Class Rule Changes

International Formula Windsurfing Class Association

Effective date: 2023-02(Feb)-17

Amendment One

FIG A - Fig A reports the National Letters, Sail Numbers and Class Insignia approximated position

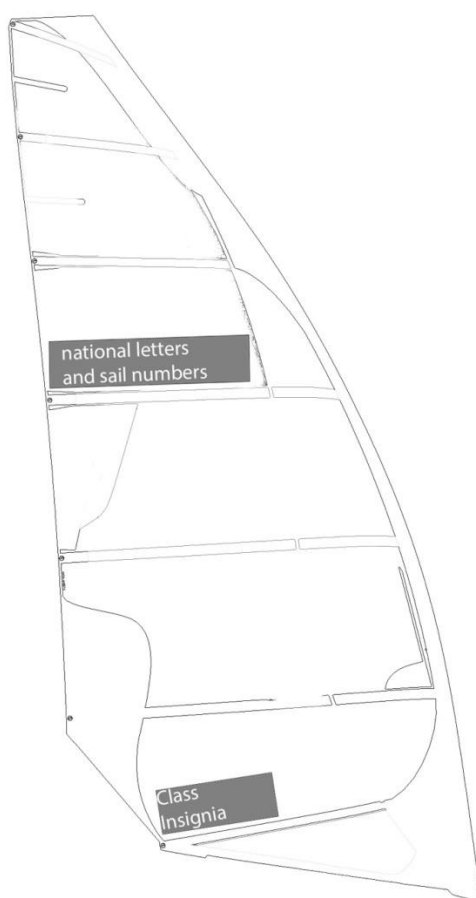
C.8.2 IDENTIFICATION

RRS Appendix B.9, G.1.1(a), G.1.2 and G.1.3 are changed as follows.

(a) The sail shall carry the National Letters and Sail Numbers as specified in FIG A below. The height of characters and space between adjoining characters on the same and opposite sides of the sail shall be as follows:

Minimum height	190 mm
Minimum space between characters and from edge of sail	20 mm

(b) For World Championships and Continental Championships, the class insignia shall be placed on the sail as specified in Fig A below. The Class Insignia shall comply with the following specifications:

Minimum width	160 mm
Minimum height	140mm
